To: T10 Technical Committee
 From: Rob Elliott, HP (elliott@hp.com)
 Date: 27 October 2006
 Subject: 06-275r0 SAS-2 ALIGN insertion rate during STP connections

sas2r06 - Serial Attached SCSI - 2 (SAS-2) revision 6

Figure 2 — Throttling ALIGNs lost during repeated primitive

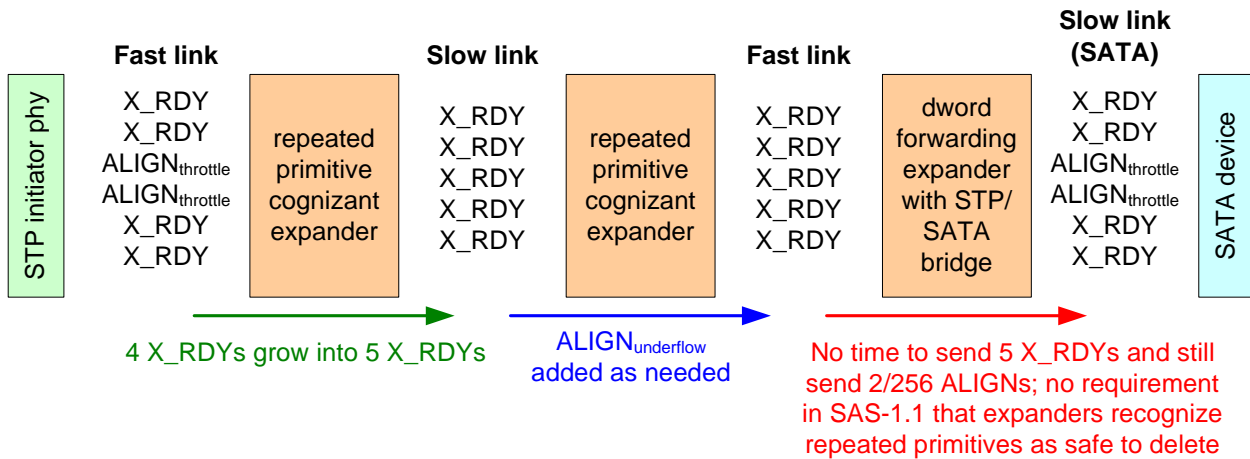
If the ALIGNs appear inside a repeated or continued primitive, however, an expander that detects it is in the state of receiving that primitive and places its transmitter in the state of transmitting that primitive could forget that it must preserve those throttling ALIGNs - not necessary 1 for 1, but the rate they occur must be the

same. If it does not preserve them, it causes cause overflows in an STP/SATA bridge that expects them (to meet its SATA obligation of inserting 2/256 ALIGNs).

This type of expander must make a special effort to transmit the throttling ALIGNs. It can simply insert 1/128 ALIGNs back into the data stream to meet the rule. It must not blindly insert 1/128 + 1/2048, however, or it will cause eventual overflow of its own buffers if it is receiving from a fast link (e.g., +100 ppm) and has a slow transmitter (e.g., -100 ppm) (this would only cause a problem if the link was transferring dwords other than repeated or continued primitives - losing a repeated or continued primitive is safe as long as at least one gets through and, for continued primitives, the CONT is not dropped).

Figure 5 — Receiving a repeated primitive sequence

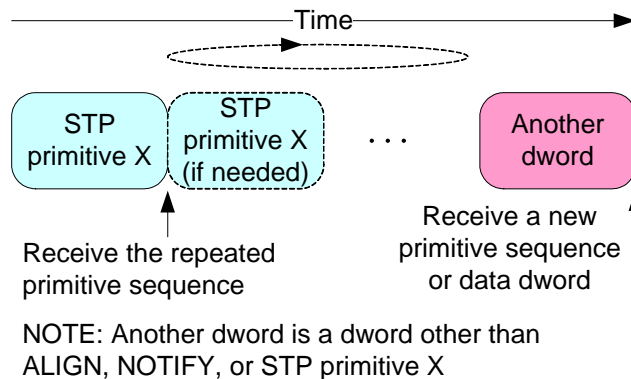
Receivers do not count the number of times a repeated primitive is received (i.e., receivers are simply in the state of receiving the primitive). [An expander device forwarding a repeated primitive sequence may transmit more repeated primitives than it receives \(i.e., expand\) or transmit fewer repeated primitives than it receives \(i.e., contract\).](#)

Figure 141 — Elasticity buffers

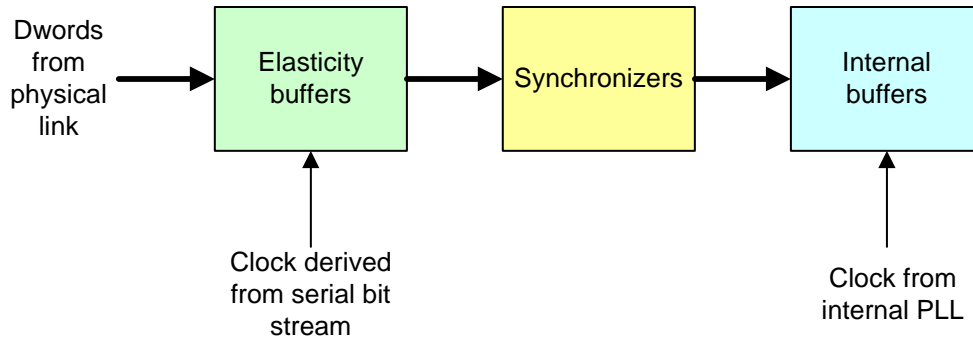
Elasticity buffer circuitry, as shown in figure 141, is required to absorb the slight differences in frequencies between the ~~SAS initiator phy, SAS target phy, and expander~~ phys. The frequency tolerance for a phy is specified in 5.3.3. The depth of the elasticity buffer is vendor-specific but shall accommodate the physical link rate tolerance management ALIGN insertion requirements in table 101.

Figure 170 — Receiving a continued primitive sequence

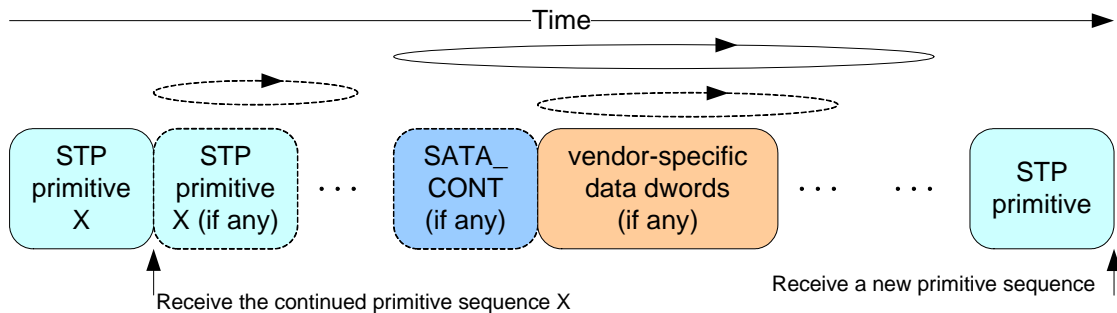
An expander device forwarding a continued primitive sequence may transmit more dwords in the continued primitive sequence than it receives (i.e., expand) or transmit fewer dwords in the continued primitive sequence than it receives (i.e., contract).
